## ADDENDUM NUMBER THREE

January 21, 2022

System Operations Center  
Henderson Water Utility  
Henderson, Kentucky

(Solicitation Number: 2022-01)

# Headquarter's Building Revised Window Plan

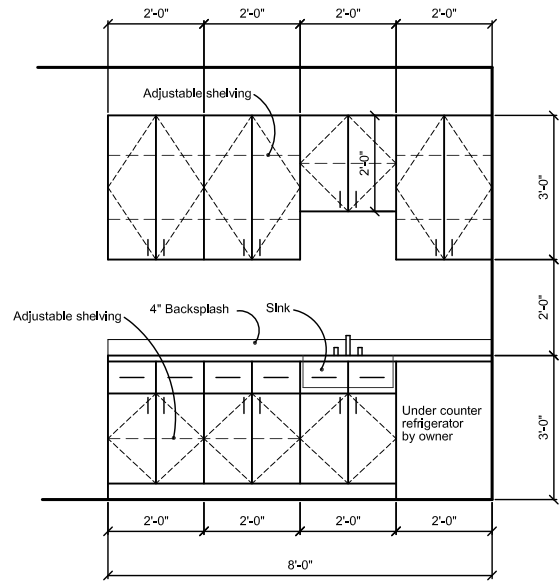
- A. Furnish and install new HMF Window Type “C” in room 148 at shown.  
(see attached drawing: Headquarters’ Building Revised Window Plan)

# Revised Casework Elevations

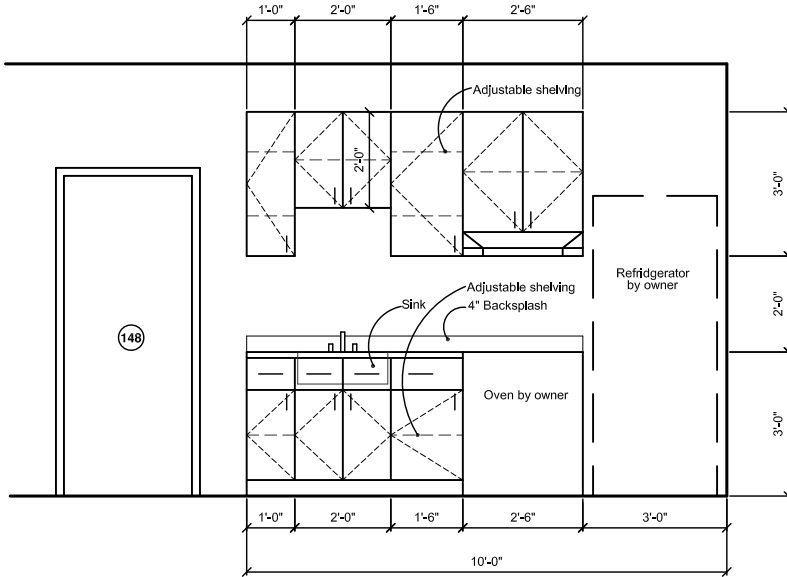
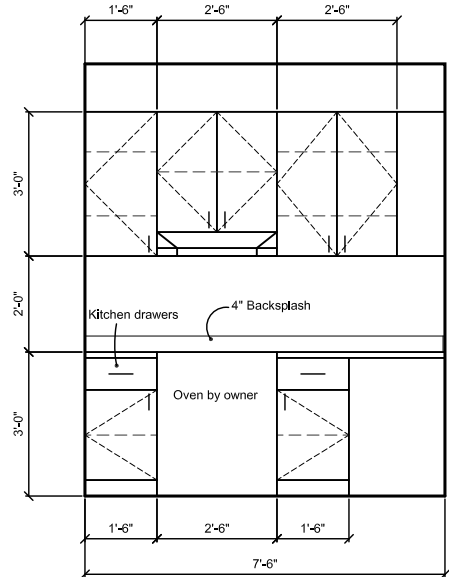
- A. See attached casework elevations deleting cabinets to provide locations for Owner supplied appliances. (see attached drawing: Revised Casework Elevations)

## Revised Window Elevations

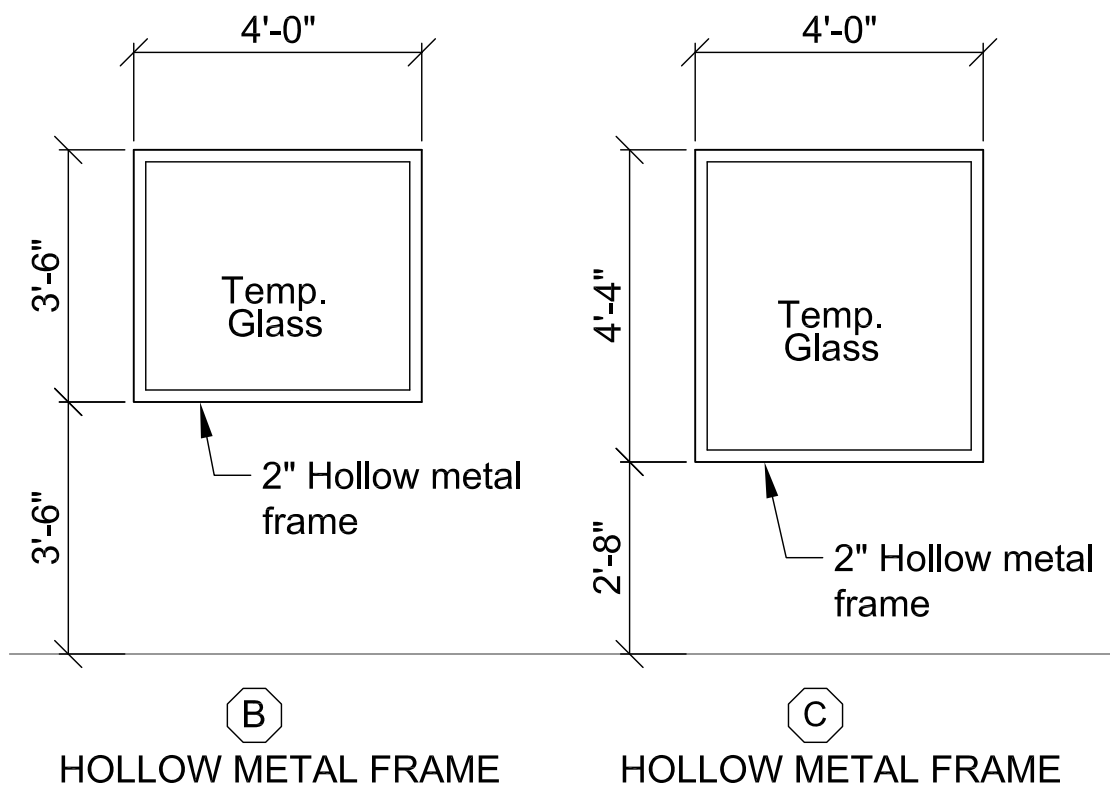
- A. Window type “B” & “C” to be Hollow Metal Frame as shown in lieu of Aluminum. (see attached drawing: Revised Window Elevations)
